Notice of Intent

Type of Action: APD Change

**Procedure Description:** OXY USA Inc. respectfully requests approval to amend the subject well(s) AAPD to update the production string cement from 13.2ppg Class H/Poz slurry to a 13.3 Class C/Poz slurry. See the attached drill plan revision summaries and lab test for reference. No surface hole changes or additional disturbance are related to this sundry.

**Laboratory Cement Test Report**  
**MIX 2023-3651 – OXY – HP479 – CHUCK SMITH MDP1 8\_17 FED COM 022H – Production – 13.3ppg**  
**Tail**  
**Service Order: 74499**

**UCA Compressive Strength**

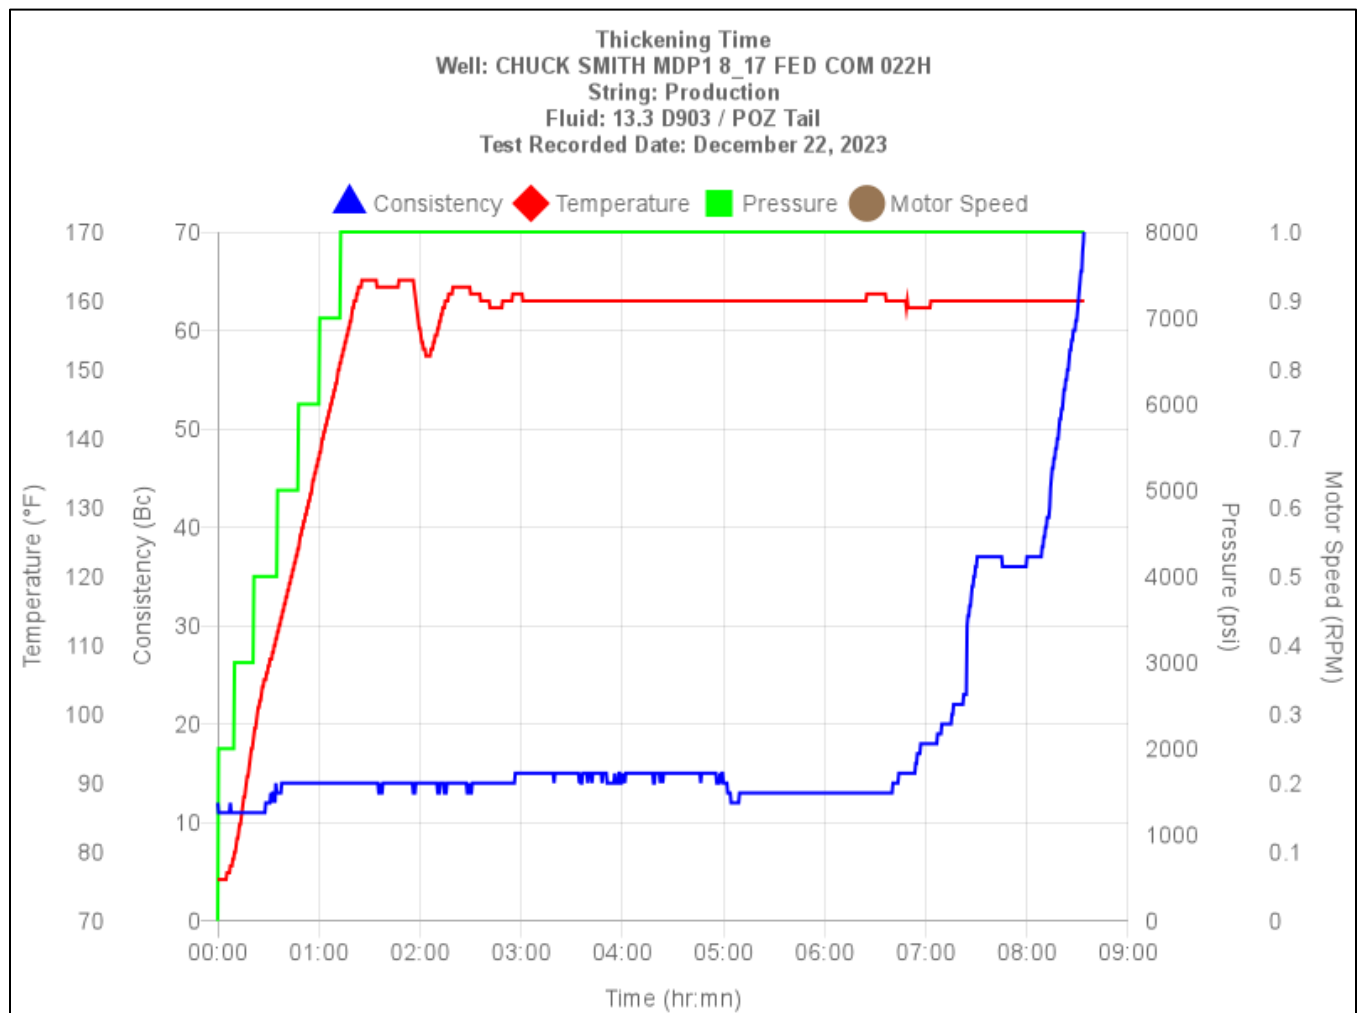
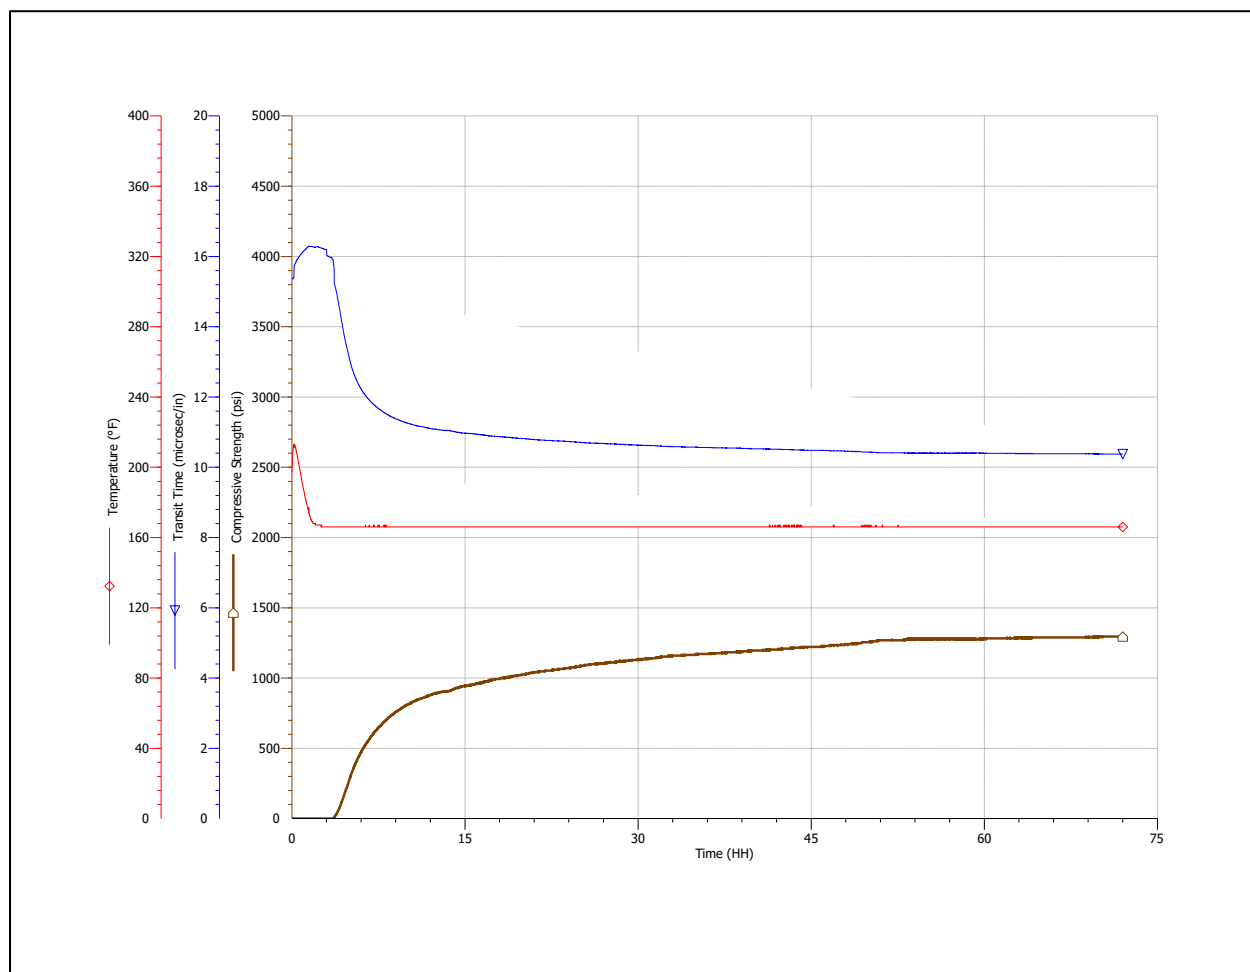
Note: When compared to the Class H / Poz system(s), the Class C / Poz slurry achieved earlier (faster) compressive strength development.

Class H / Poz: 500 psi 13:12 hr:mn

Class C / Poz: 500 psi 06:10 hr:mn

Time	Compressive Strength	Temperature
03:58 hr:mn	50 psi	160 degF
06:10 hr:mn	500 psi	160 degF
24:00 hr:mn	1069 psi	160 degF
48:00 hr:mn	1241 psi	160 degF
72:00 hr:mn	1294 psi	160 degF
Machine S/N:	640
